**MAY 2024**

## **Westbrook CSO Master Plan Update**

## For the Portland Water District and City of Westbrook, Maine

**Figure 5-6 WP Meter Basin 102-13 Supplemental Meter Locations 3 and 4**

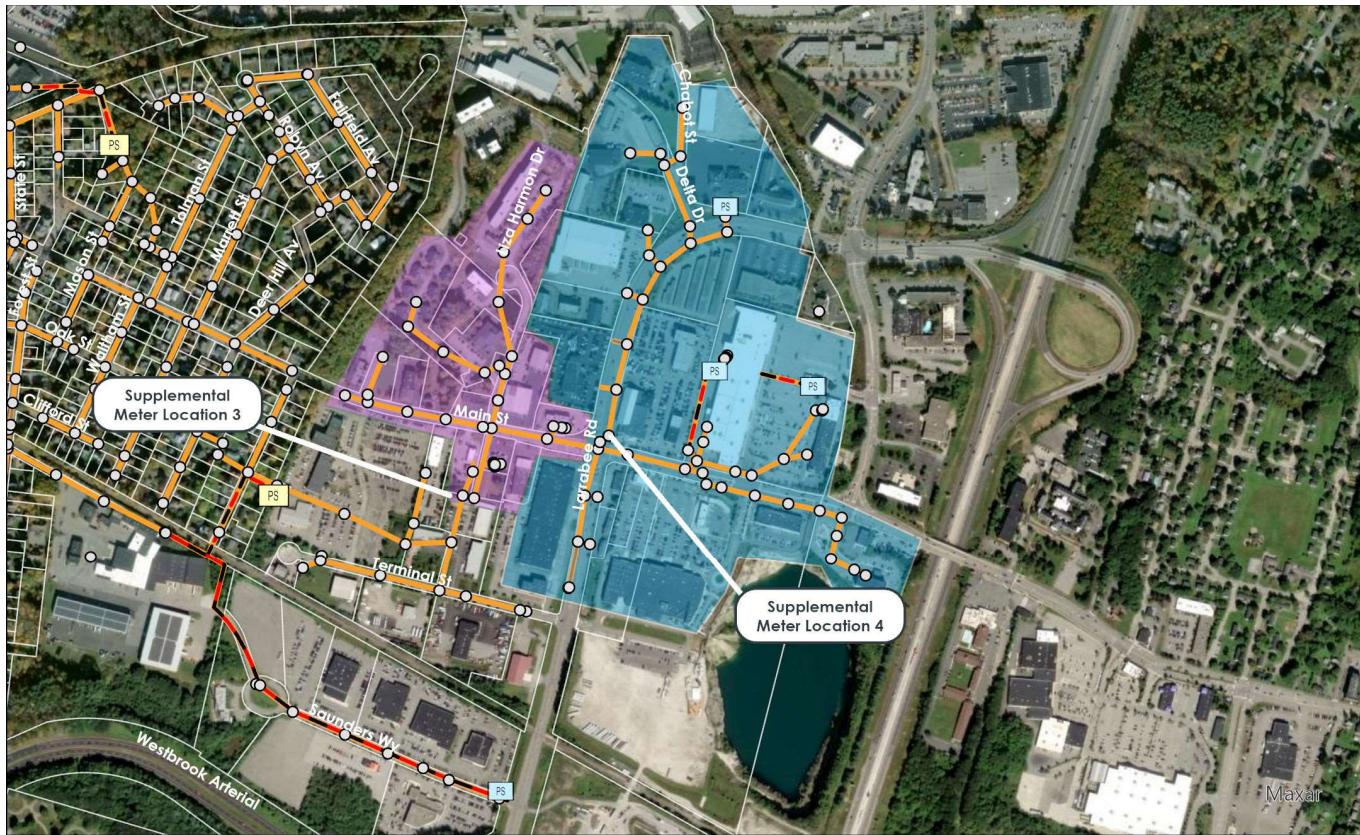
21. Figure 5-6: There are a lot of flat roofs in this meter basin. Are roof leaders on any of these buildings part of the 41 that are known to still be connected to the sewer system?
